Mystic Woods Active Adult Community Groton, Connecticut

Environmental Review Team Report

Inland Wetland Agency
and Planning Commission
Groton, Connecticut

March 2007

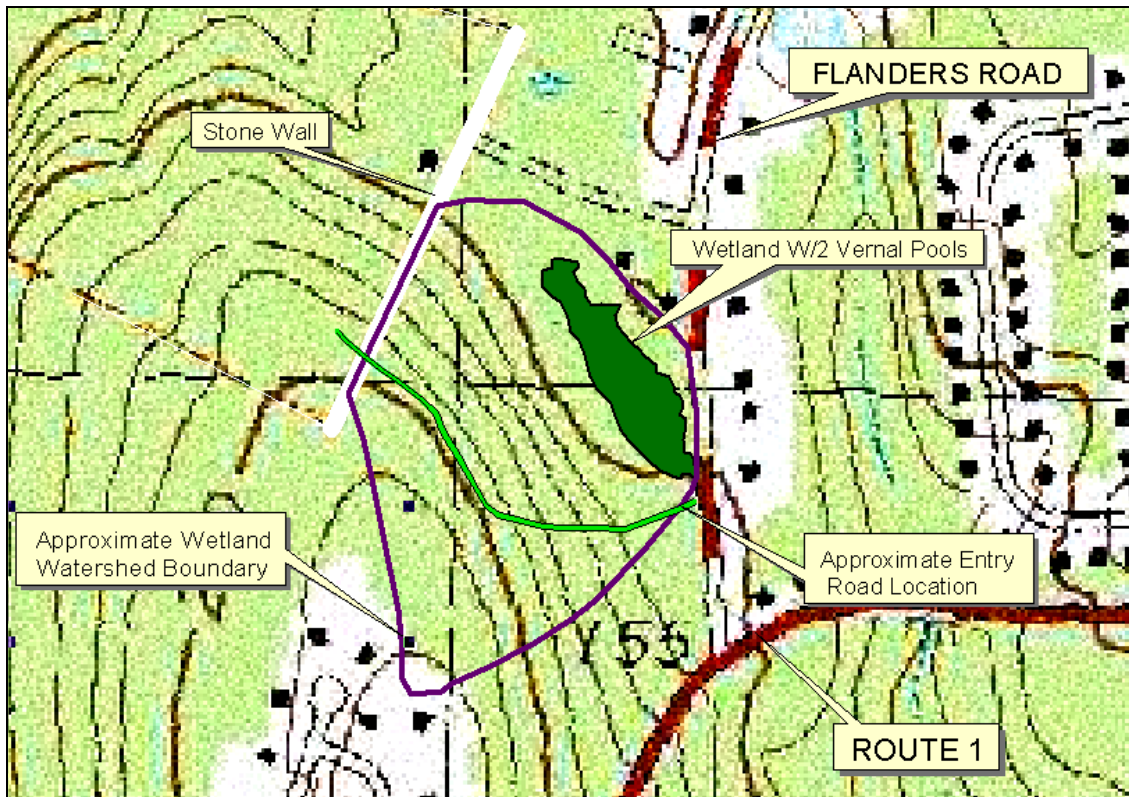
As depicted on the graphic below, this reviewer has estimated the total watershed for this vernal pool/ wetland system to be ± 14 acres. Almost the entire watershed is to the west and southwest of the wetland. Just a small portion of the watershed is to the east and north/northeast. The ten or so acres that feed the wetland from the west and southwest will be divided roughly in two by the entry road. And this is the quandary of the matter. Given the information Dr. Klemens et al supplied above, and the fact that these are breeding vernal pools, the applicant would need to show how best to preserve this documented resource.

For instance, a revised proposal might offer to free the entry road area of congestion by the removal of units 66, 67, 68, and 69. This would “unsqueeze” the entry road, minimize the need and/or size(s) of detention basins, and allow the road to sweep further away from the wetland. All of this would decrease the need to treat runoff that would be redirected into the wetland system.

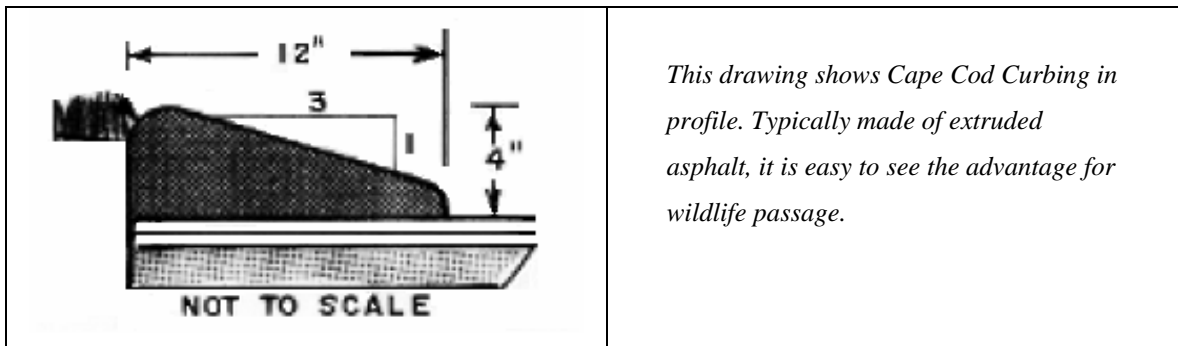
Use of Curbing - Curbs often function as a means of channeling water to storm drains. To minimize the flow to the storm water system, where possible, the applicant should be encouraged to use no curbs (typically in low gradient areas). This allows runoff to more easily infiltrate in non-point locations. It also serves to take the pressure off of the

In addition, the main road way in the vicinity of the vernal pool wetland will cut across amphibian migration paths. Vertical curbing does not allow for the passage across the road way of small amphibians. The curb walls are cliff-like to them and form an insurmountable presence. Cape Cod Curbing however, because of its gentle profile does allow for the migration from the pool to the upland and back because of its lower over all height and low gradient slope.
